H11973

DESCRIPTIVE REPORT

Sublocality Vicinity of Spanish Canyon

Revisions and Corrections Compiled During Office Processing and Certification

Figure 2 Profiles of 3BC02-TIE01 and 3BC02-TIE02

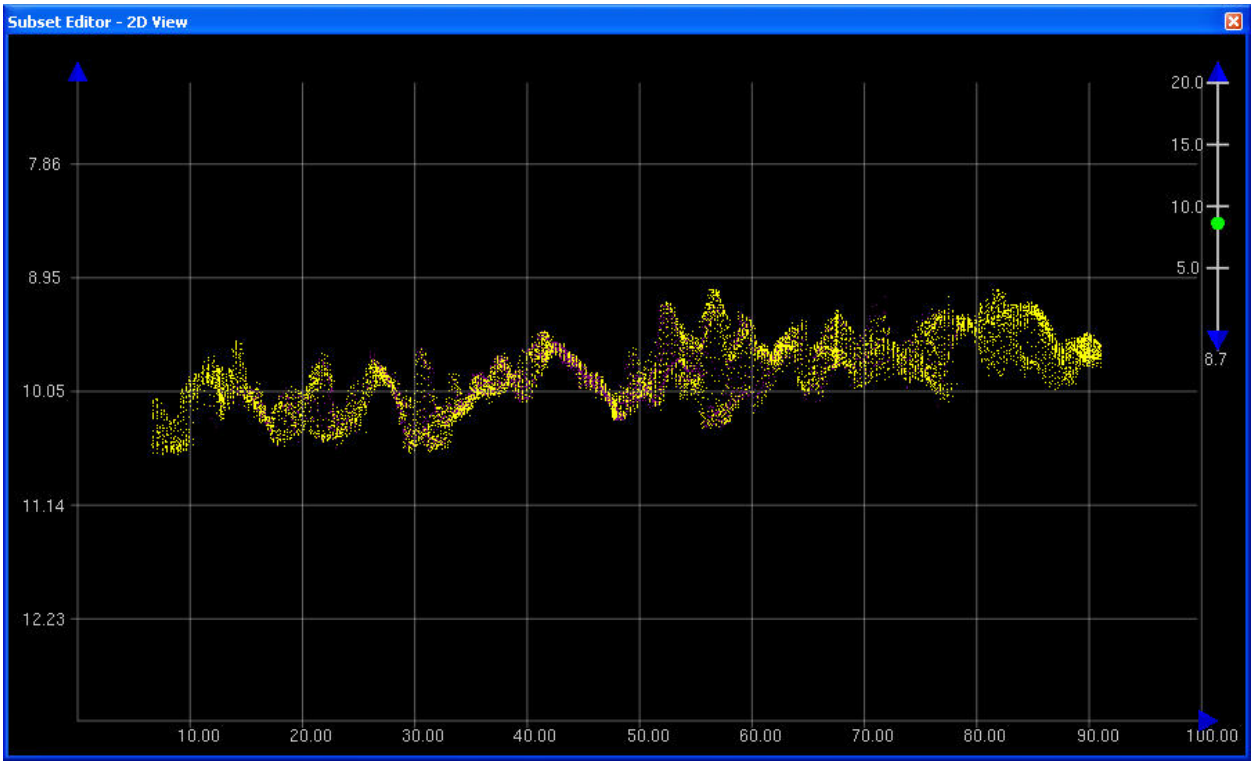
The majority of beams that fall below the 95 percent confidence level are located in areas having extremely steep slopes and/or rocks, as well as in areas with dynamic bottom issues. **Figures 2** and **3** below provide examples.[2] Note: Main scheme lines are shown in yellow and crosslines in purple.

[1] Concur.
[2] The data is adequate to supersede charted data in the common area despite falling below the 95% confidence level on the crossline comparison.
[3] Concur. The areas of higher uncertainties discussed in this section are in situations where it is expected and, in those cases, deemed acceptable.
[4] A common junction was made with H11972, which has already been compiled. A common junction with H11974 will be made when that survey is compiled.
[5] Concur.
[6] Concur.
[7] Concur. The data is adequate to supersede charted data in the common area.
[8] Concur. Given the small scale of the chart, the small holidays are insignificant and the data is adequate to supersede charted data.
[9] Concur.
[10] Concur. The data is adequate to supersede charted data in the common area despite the vertical errors between data collected in dynamic areas at different times.
[11] A 10m combined surface was created during the Survey Acceptance Review and was used as the basis of compilation.

Figure 4 Uncertainty DTM

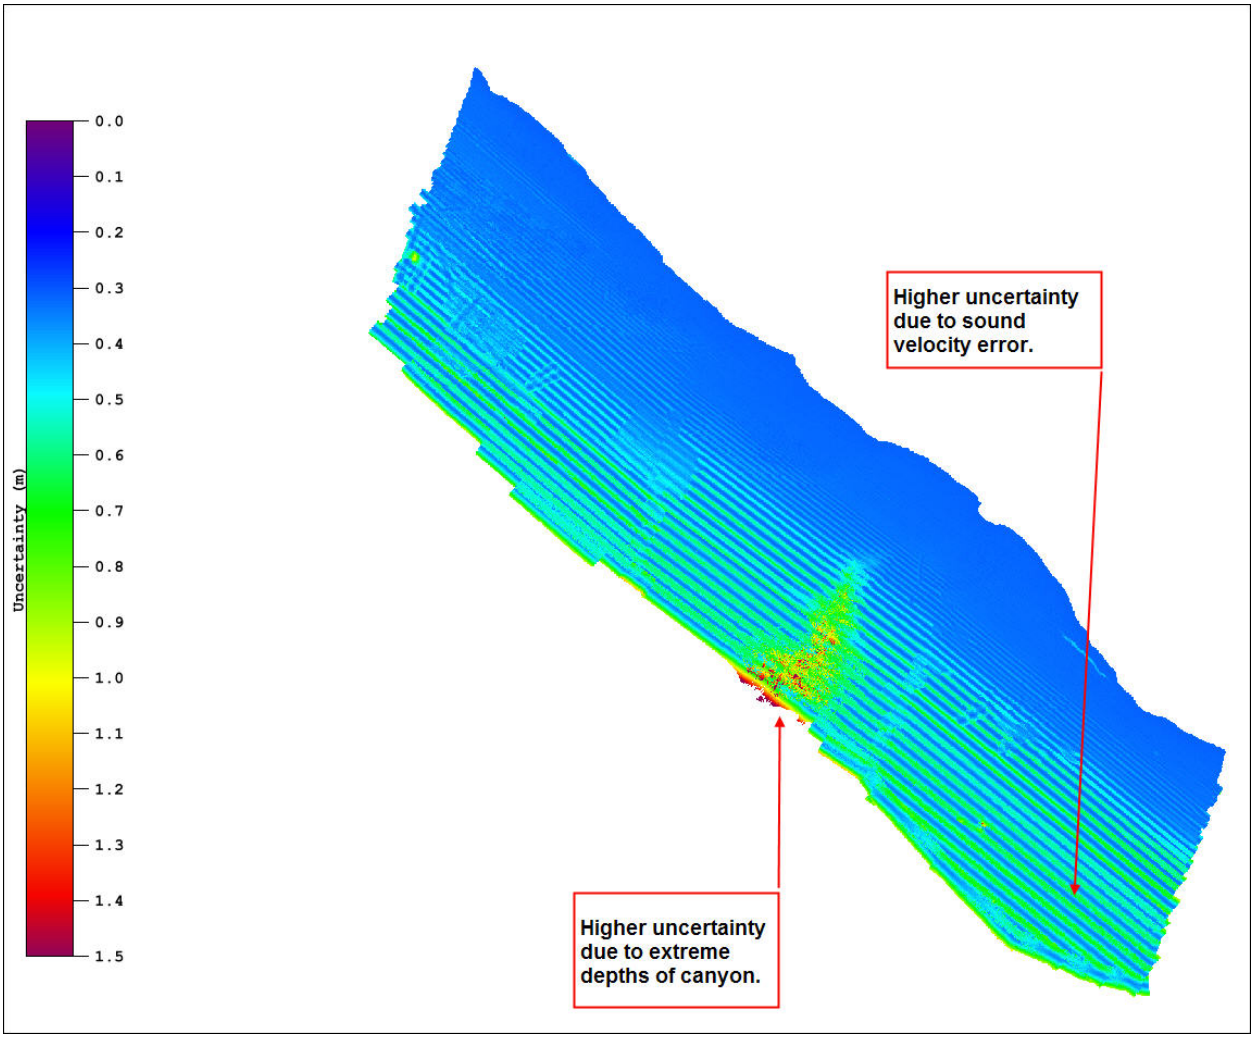
As seen in the uncertainty surface (**Figure 4)**, uncertainty is generally lowest near the sonar nadir beams and increases toward the outside of each swath. This is expected and primarily a result of sound velocity error uncertainty.

Oscillations along track and port to starboard in the uncertainty surface are due to higher uncertainty computed due to vessel roll, again prevalent mostly in the outer beams.

Spanish Canyon and outlying areas of the sheet produced higher uncertainty due to decreasing data density as a result of the deeper depths.

Other areas of higher uncertainty include rock outcrops and irregular bottom topography.

Figure 5 H11973 Survey Junctions

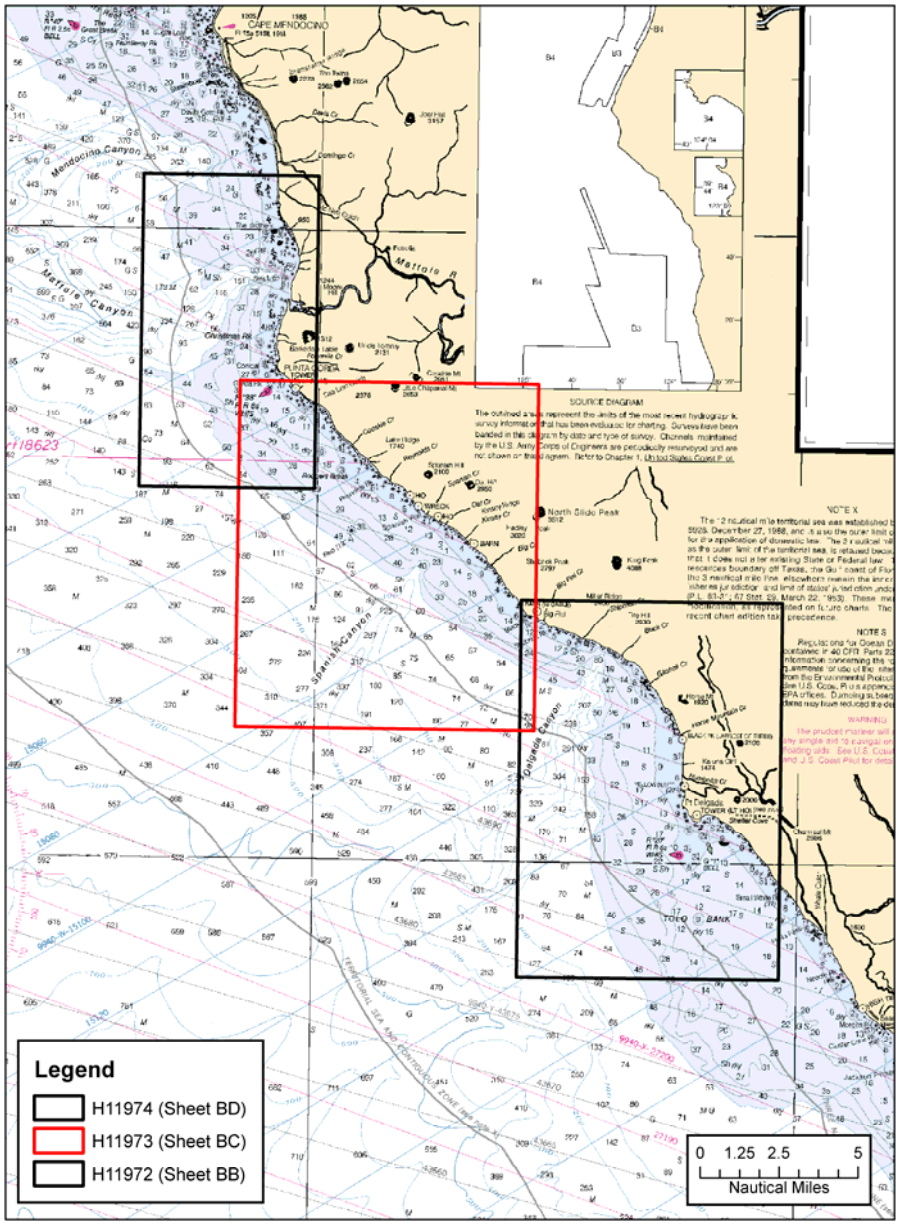
The surveys are in agreement along their common borders. The agreement was noted in the field using the CUBE surfaces during subset cleaning. The conformity is also apparent in the Final Combined BASE Surfaces.[5]

Figure 6 H11973 Difference Surface (Tidal minus GPSTide)

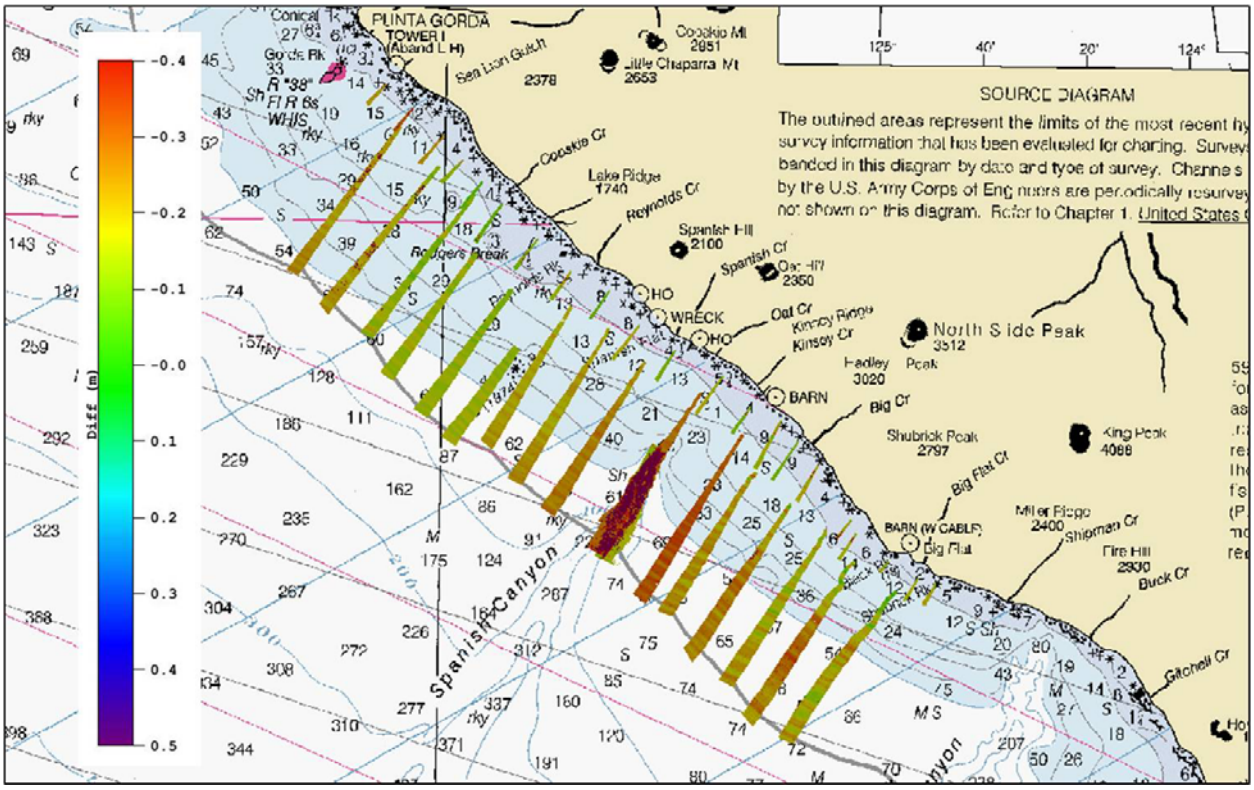
Results: Average difference was -0.180 m median difference was -0.18 m, with a standard deviation of 0.110 m. Therefore, the GPSTide surface was about 18 cm deeper on average than the tidal surface. No significant trends were apparent, but a portion of the difference can be attributed to the high uncertainty or inability to measure the waterline (static draft) value on the Pacific Star in less than ideal sea states. See **Figure 6** below.
